TERRAIN SOLAR

The purpose of this letter is to propose a solution to Request 1(iv) from the Southern Joint Regional Planning Panel.

Figure 1: Typical Tracker Cross Section

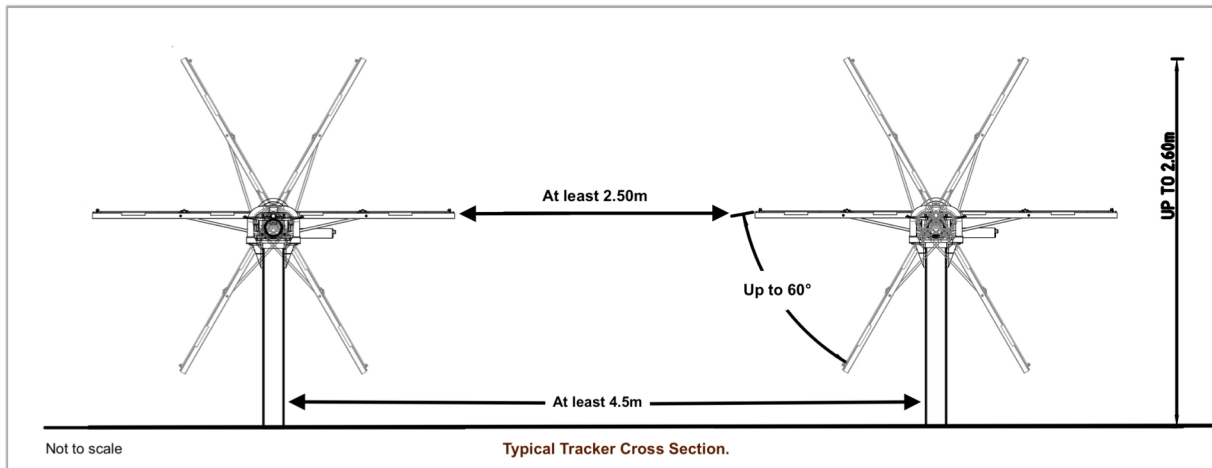
Provide the cells to be spaced a minimum of 7 metres between the structure to allow grazing

In providing a layout that allows for healthy groundcover, *Figure 1* details a typical tracker cross-section that commits to a minimum row-to-row spacing of at least 2.5m. This 2.5m spacing represents the minimum distance that the panels will be from each other and has greater relevance, to groundcover, than the tracker separation.

As mentioned above, the row-to-row to row spacing Terrain Solar are proposing is a minimum of 2.5m which is 1m more than the NREL study site. This will provide an optimal level of light and shading to support a healthy groundcover. As shown in *photo 1*, which shows an image of a tracker system in Mount Majura, ACT, groundcover thrives under the solar array due to access to both sunlight and shading.
